City of Portland, Maine - Building or Use Permit Application
 389 Congress Street, 04101 Tel: (207) 874-8703, Fax: (207) 874-8716

Permit No: 02-1001	Issue Date: JUL 09 2003	CBL: 015 E007001
-----------------------	-----------------------------------	---------------------

Proposed Project Description:
Construct 3rd fl. Addition to include balcony, bedrm and bathrm

east wall

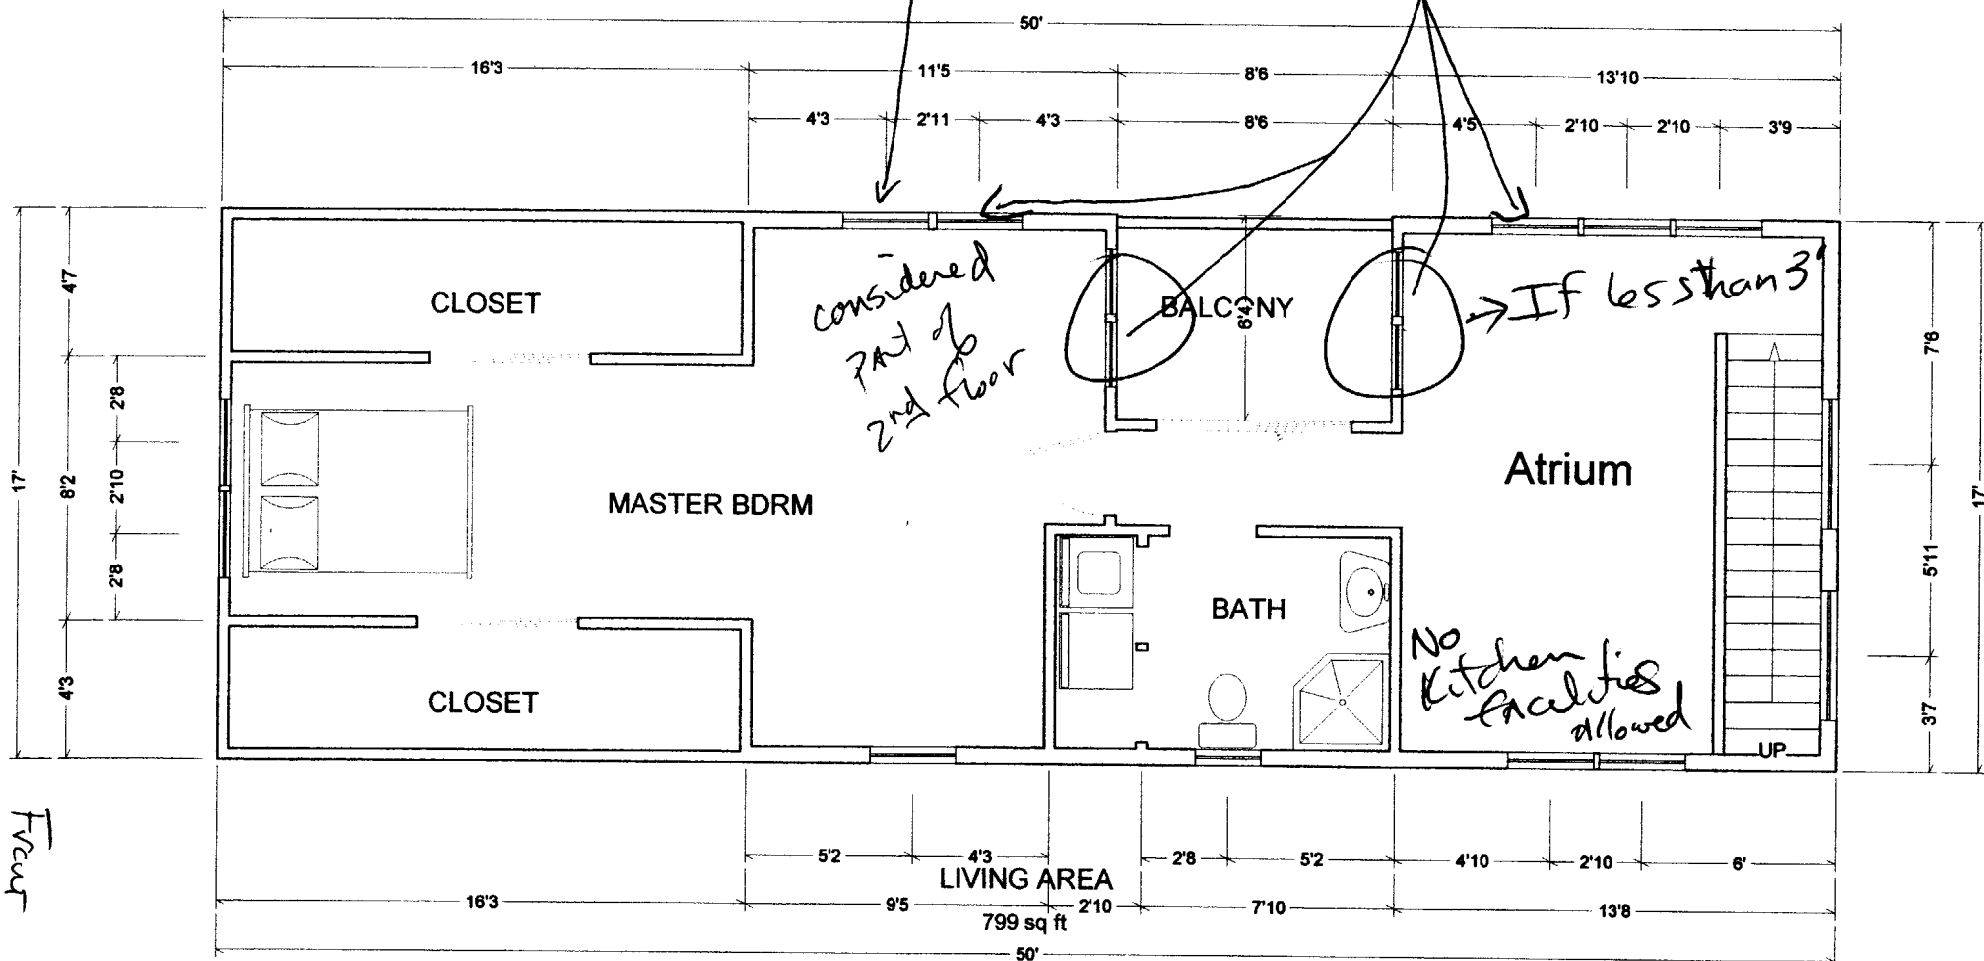
~~Possibly 3/4 hr rating~~ 1 hr. Fire Rating

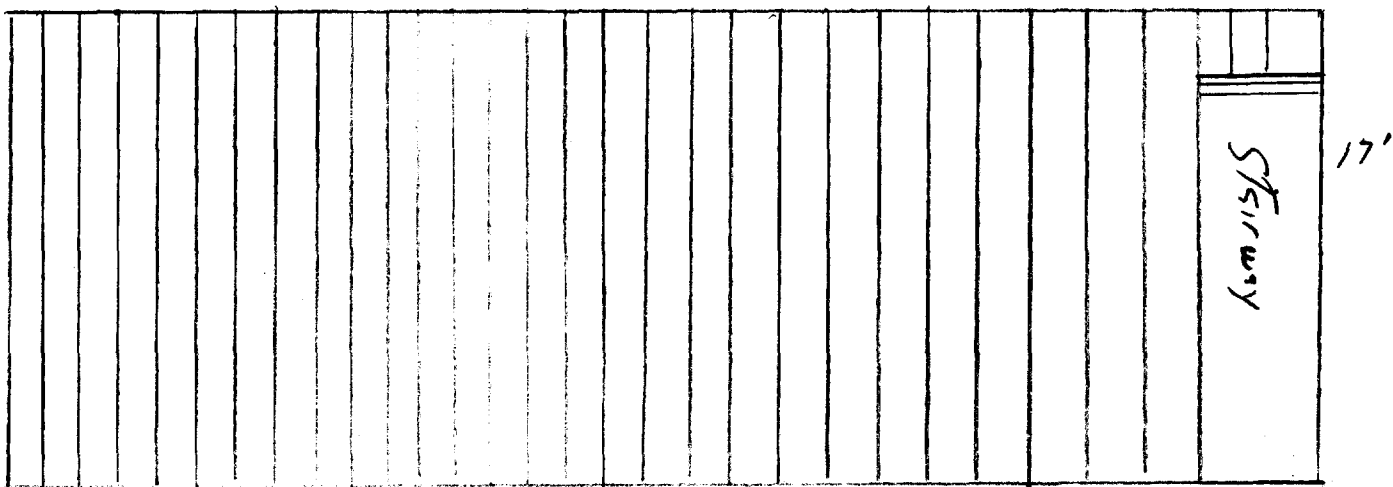
~~2x10~~ Floor Joist 16" OC

* NEEDS 2x12 Floor Joist @ 16" O.C.
 OR
 2x10 @ 12" O.C.

44 Walnut

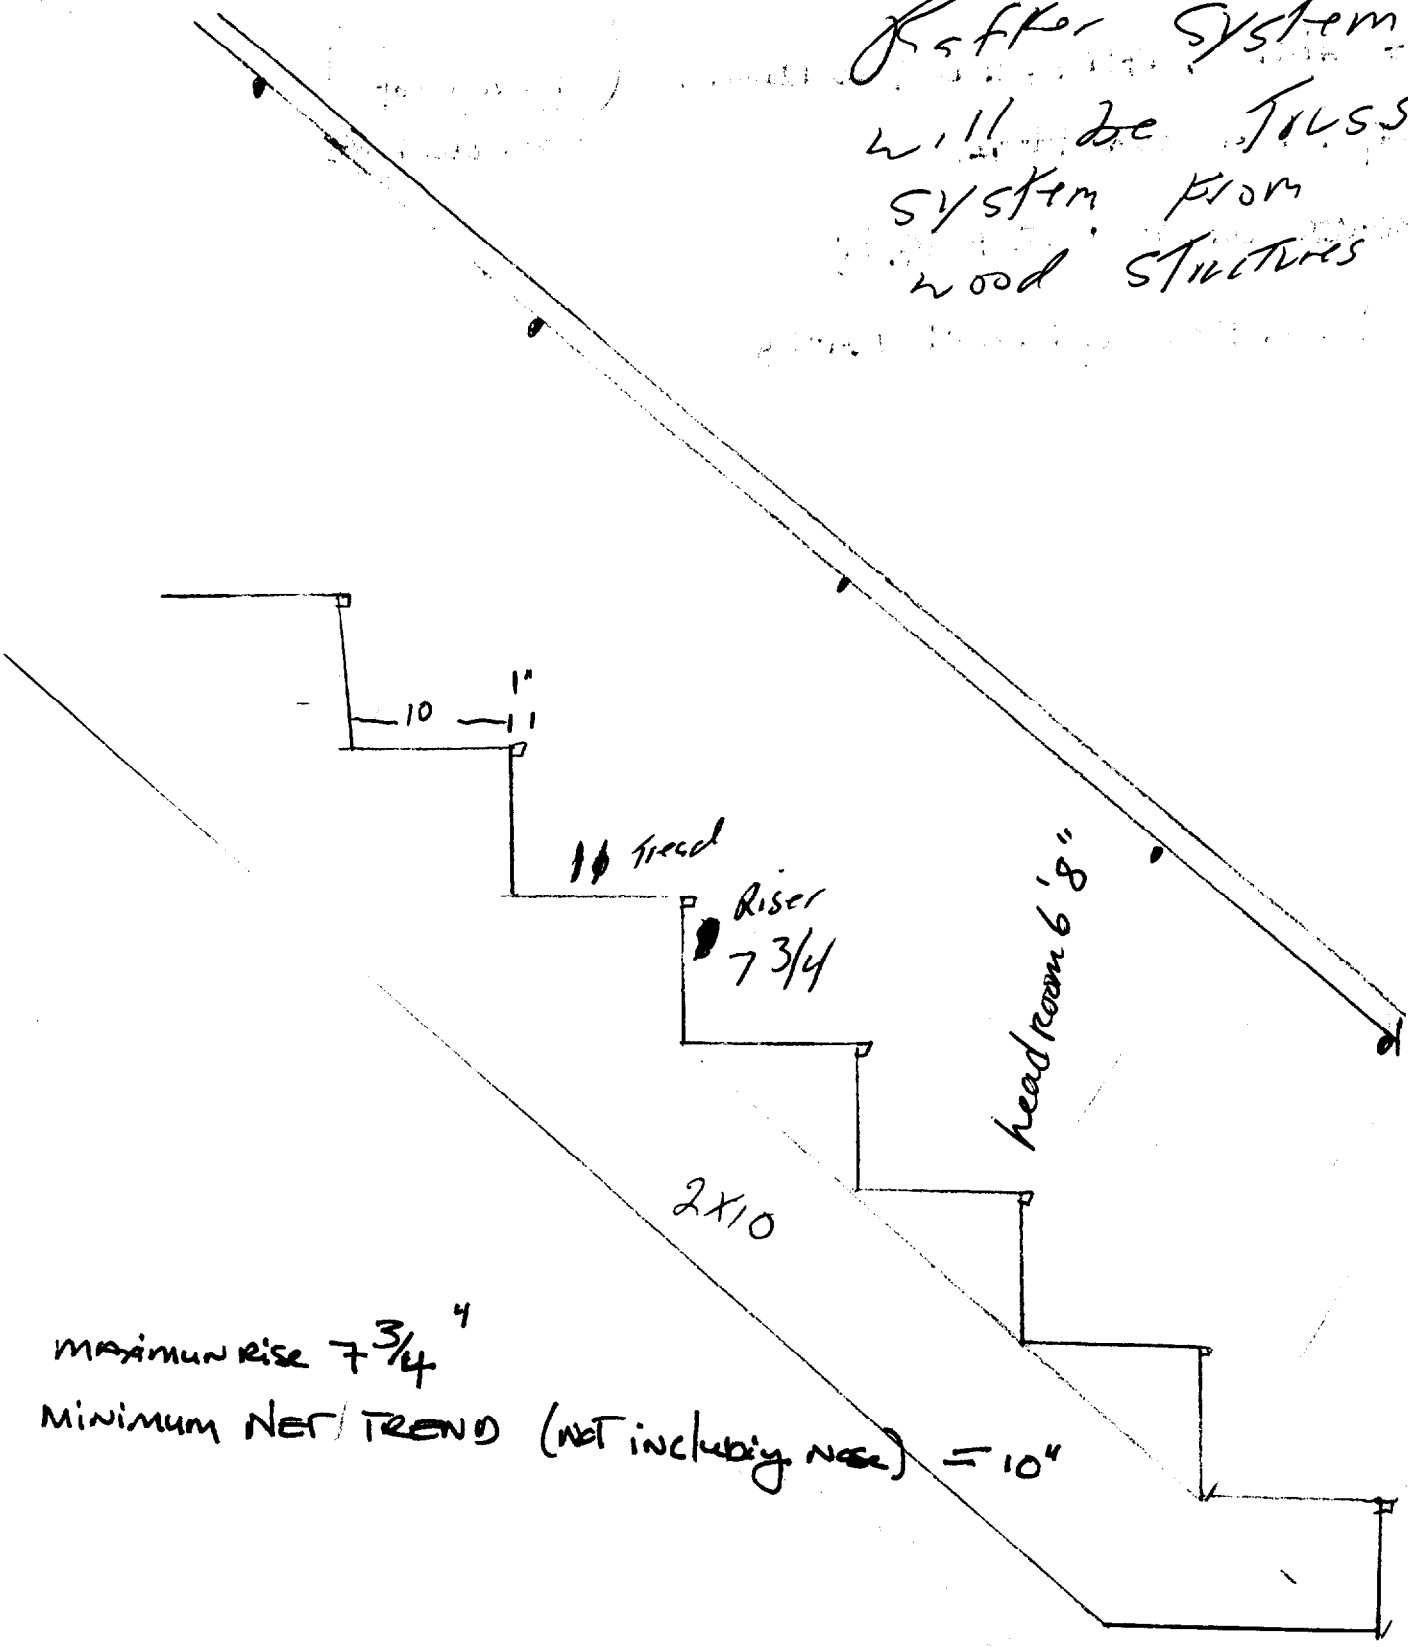
max span is 15'5"

Rafter system
will be TRUSS
system from
wood structures inc

CATHERINE SUSAN LINK
44 WALNUT ST
September 1, 2002

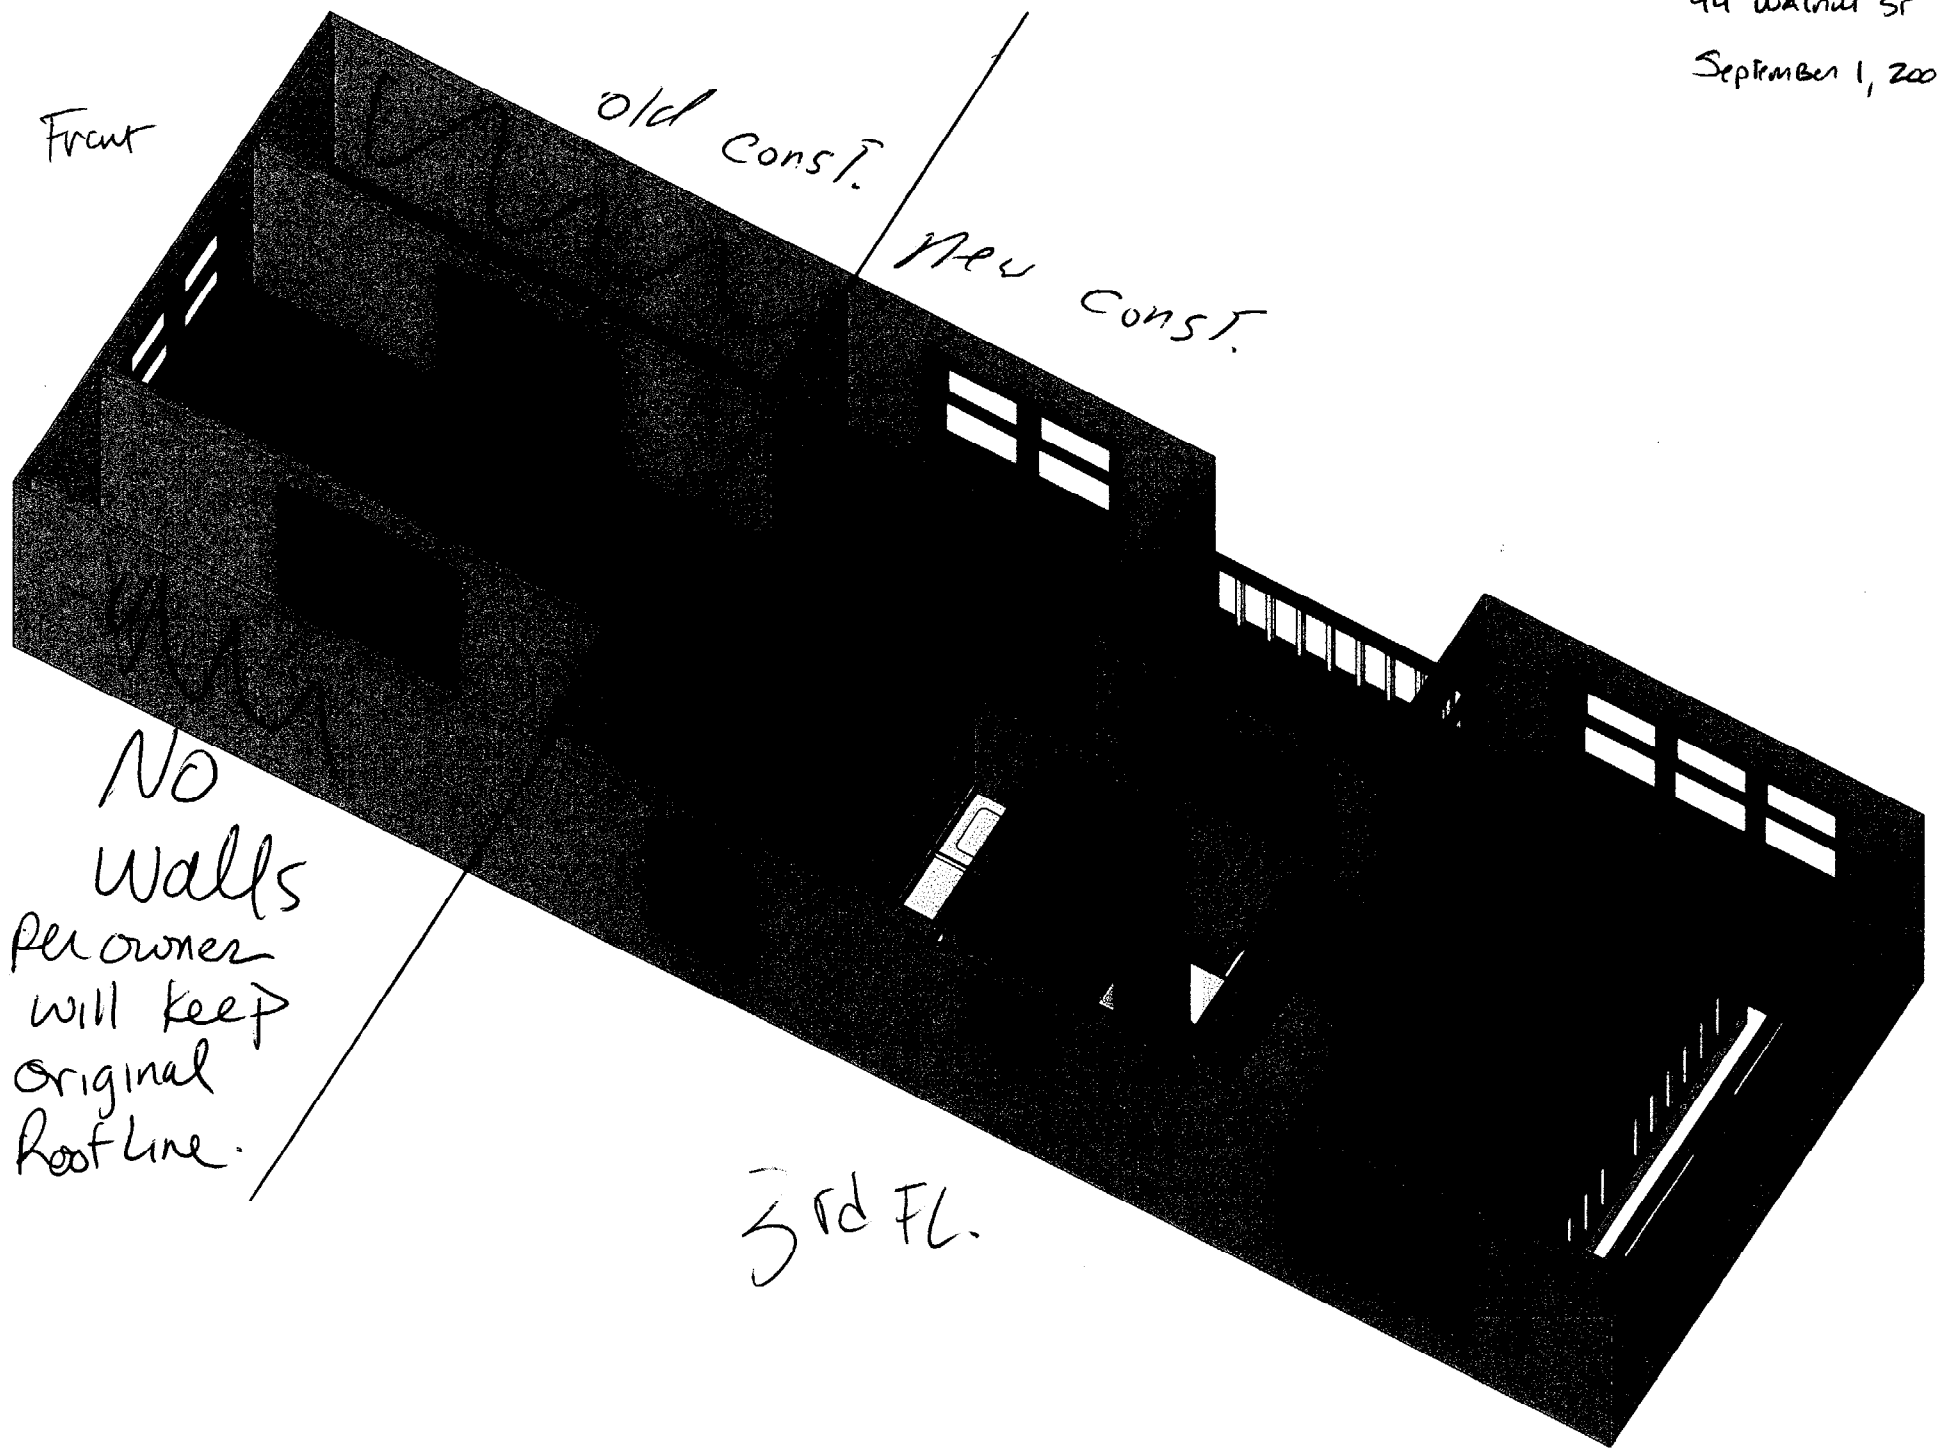
No
Walls
per owner
will keep
original
Roofline.

44 Walnut ST

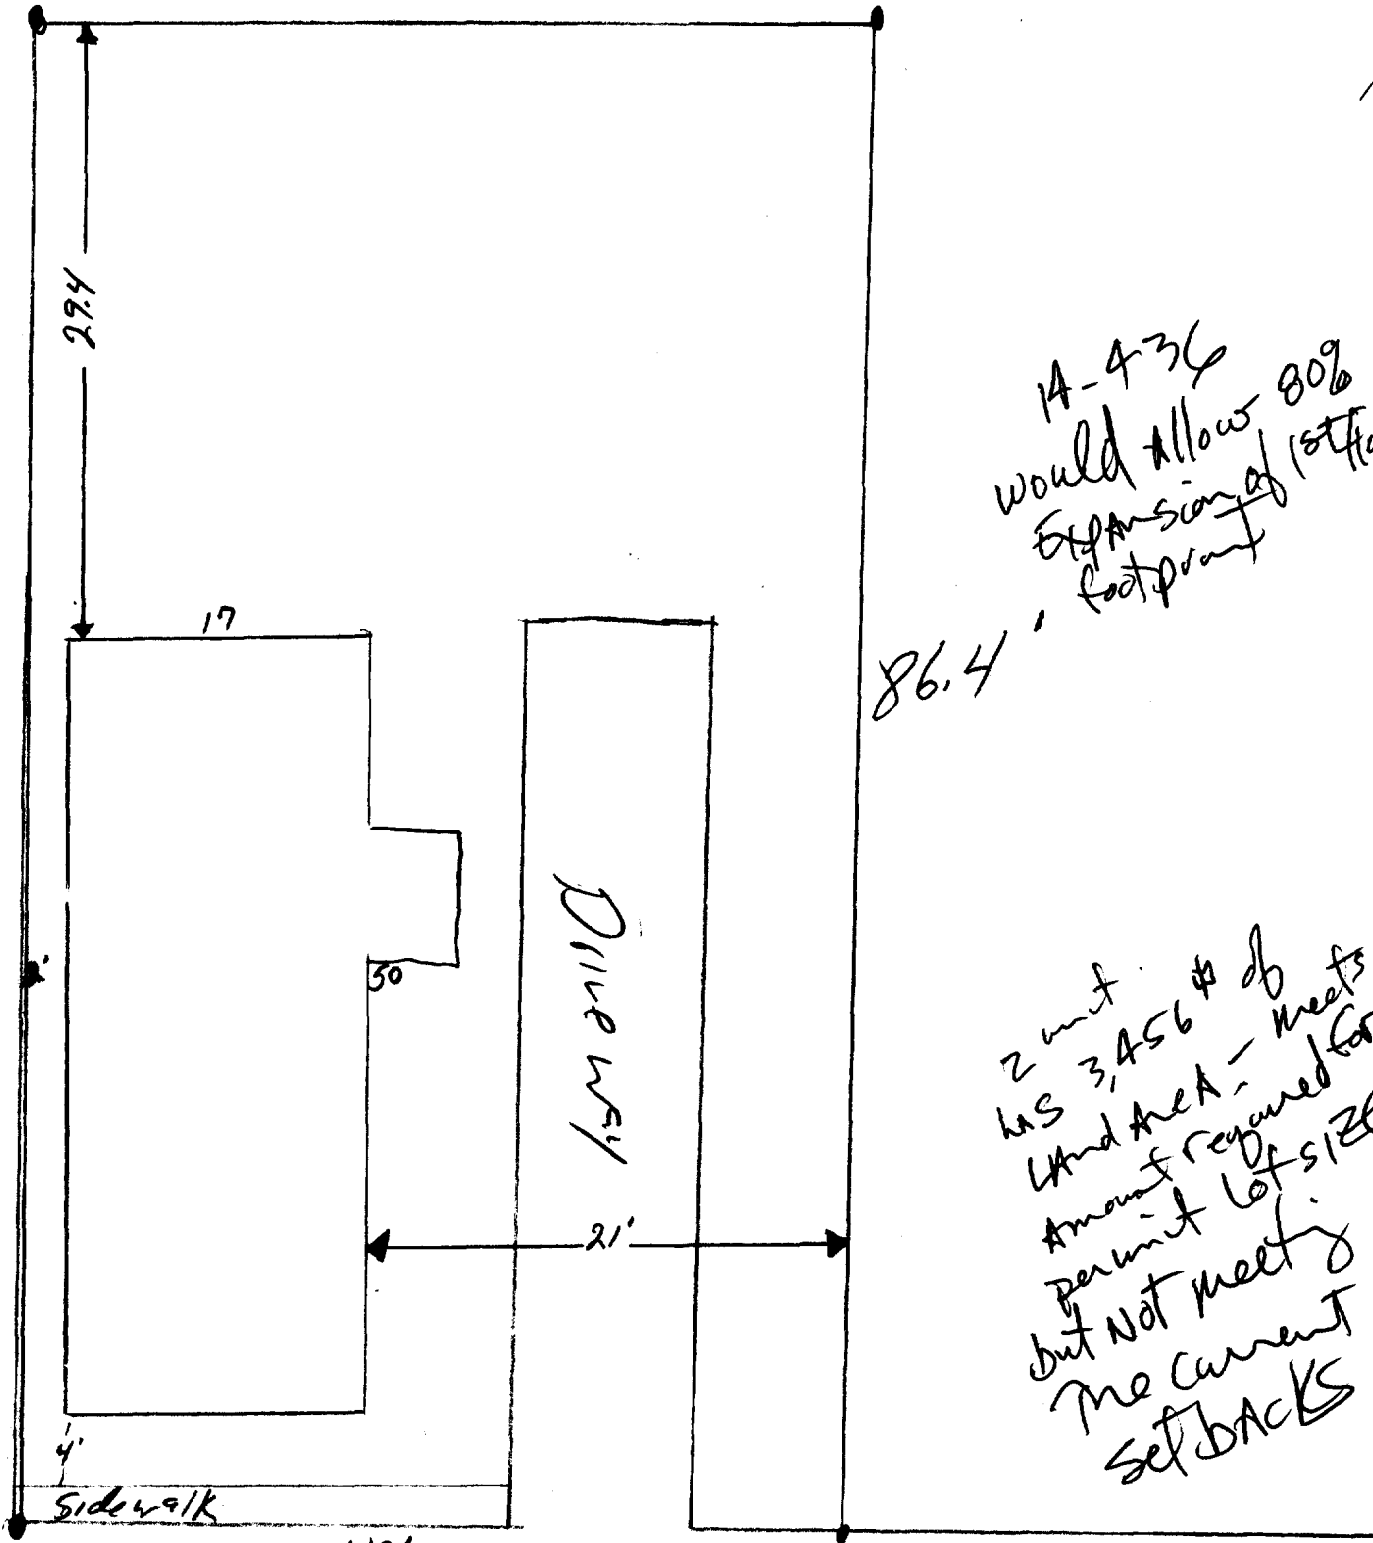
14-436 would allow 80% expansion of footprint

2 unit has 3,456 sq ft of land area - meets amount required for permit lot size but not meeting the current setbacks
